Consultation on your application no: 243127

Location: URS Building, Whiteknights Campus, Earley, RG6 6BW, Reading

Proposal: Request for observations by Reading Borough Council to Wokingham Borough Council on full application for proposed external and internal refurbishment, repairs and alterations consisting of replacement windows and doors; replacement roofs including new roof lights, cowls and lanterns; installation of solar panels; concrete repairs; full mechanical and electrical services upgrade; erection of two external staircases; new detached bin and bike store, and hard and soft landscape and accessibility improvements.

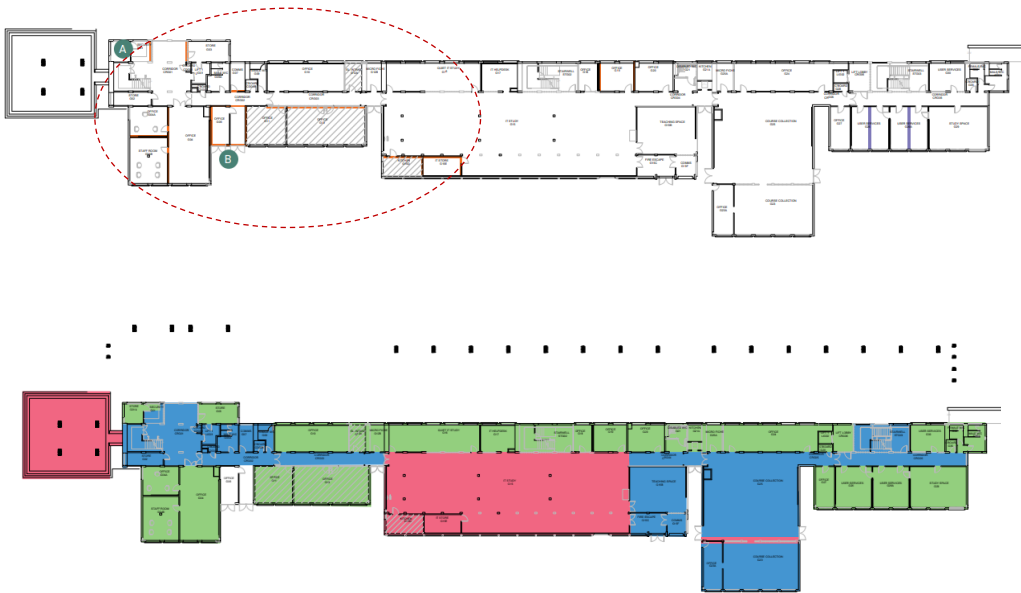
The above is the original ground floor plan (from the heritage statement). Compared with the existing plan, the circled area appears to be the most changed one. Therefore, it is hard to understand the rationale between the medium and low significance as the original plan is preserved for those areas.

Original, existing plans and significance assessment for the second floor. The difference or relationship between significance and alteration is not clear.

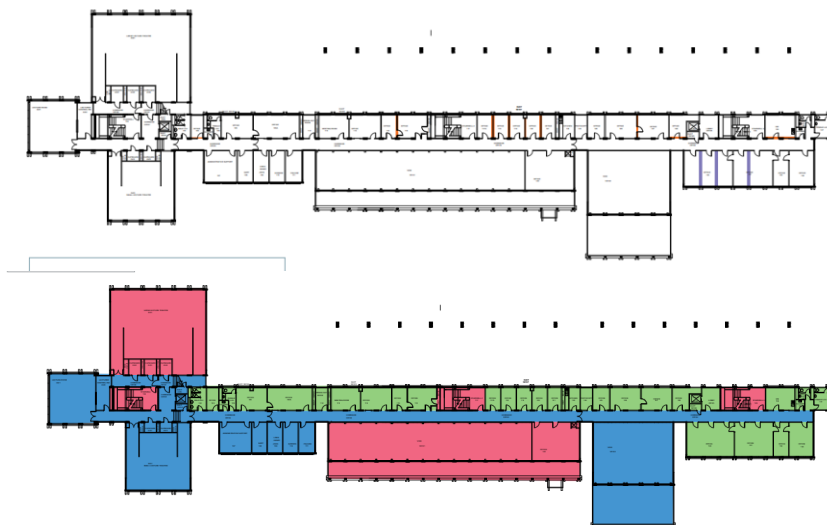
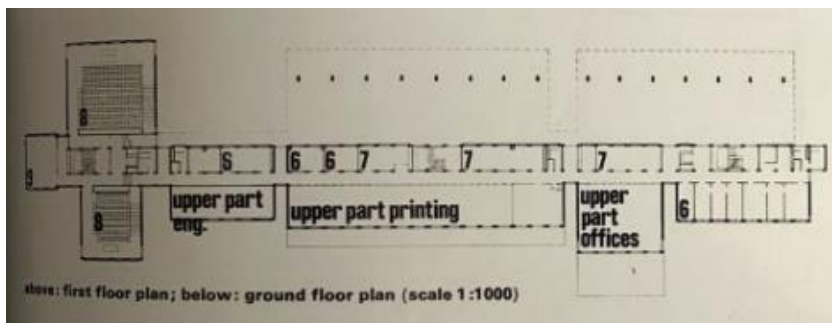
Similarly, I think the significance assessment on the floor plans needs to be revised. The internal spaces without alteration and others with alterations, for instance, on the first floor, are all indicated as low significance – green. Is this related to the non-structural partition walls, and are they not significant? That means the second-floor half of the building has some importance, which should not be the case. Defining partition walls not significant or not contributing to the special interest of the building does not mean that the spaces to the north do not form part within the significance of the building.
